Audit of the Remediation of the former Fruitgrowers Chemical Company Site, Mapua

∴ Prepared for
Ministry for the Environment

∴ June 2009

PATTLE DELAMORE PARTNERS LTD

Figure 4 : EAST MARINE EXCAVATION - Approximate Sample Locations

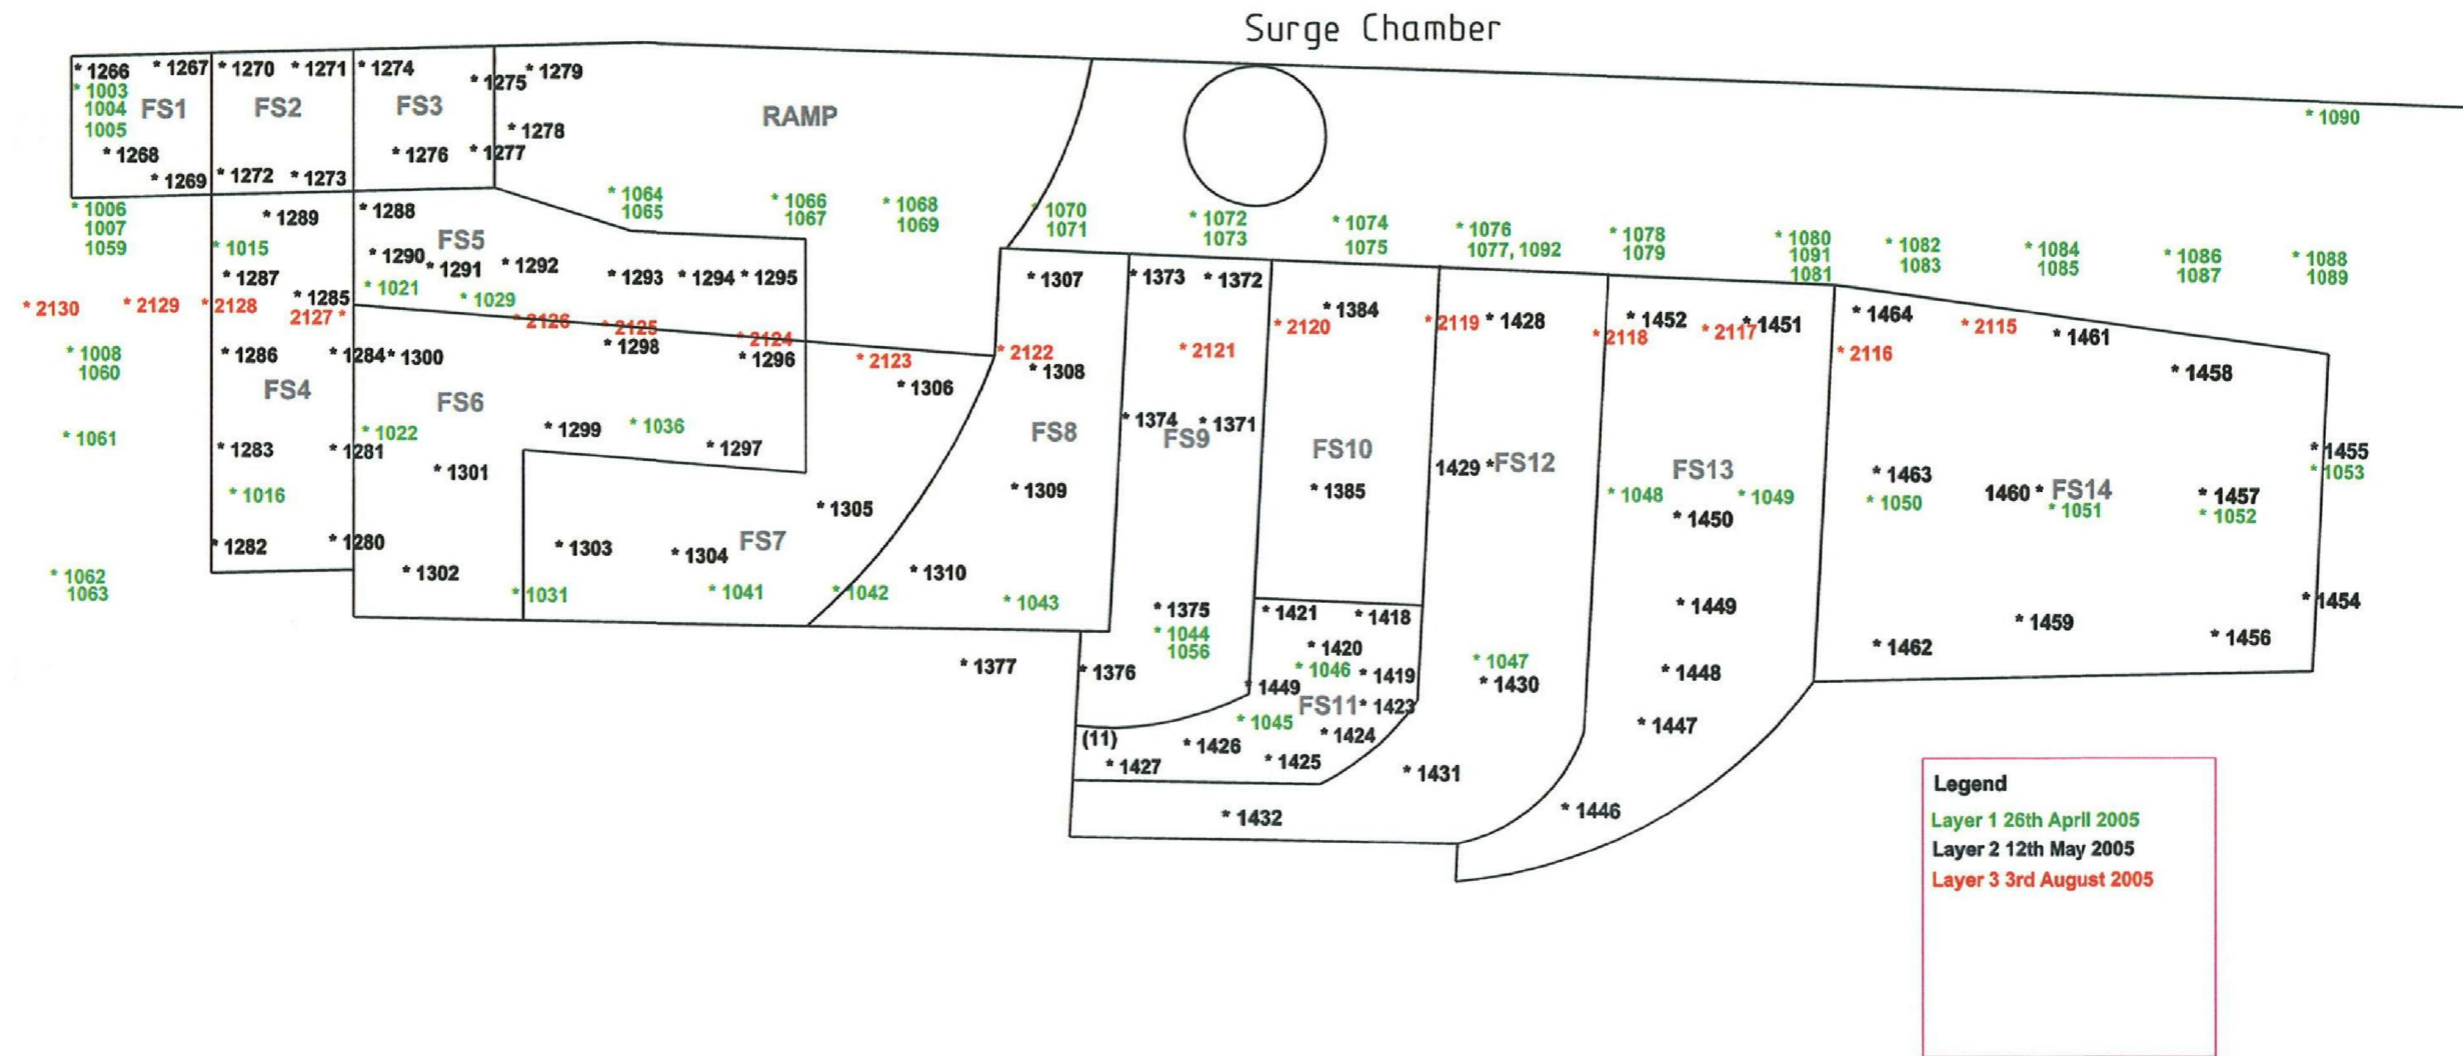
From the information obtained, it is not clear whether the area represented by the pre-excavation samples 1072 – 1089 has been remediated (Figure 4). It would appear that these areas were not included in the marine sediment remediation works i.e. they are not within cells FS1 – FS14. However, it is likely that at least the central part of this strip of beach was remediated during the works to remove the surge chamber (subgrades SG10 and SG13 on Figure 2). In addition, the works to construct the sea wall are likely to have overlapped these sample locations to some extent. This is difficult to confirm as the position of the samples cannot be accurately determined from the location plan.

A subsequent set of 16 samples was collected about three months after the remediation works. These samples were collected from approximately 0.3 m depth in a line along the beach, as indicated by the red samples on Figure 4, and analysed for the full OCP suite. It is not stated what the target stratum was for this sampling, however, the sample depth would tend to imply that the samples were collected from within the remediation backfill material.
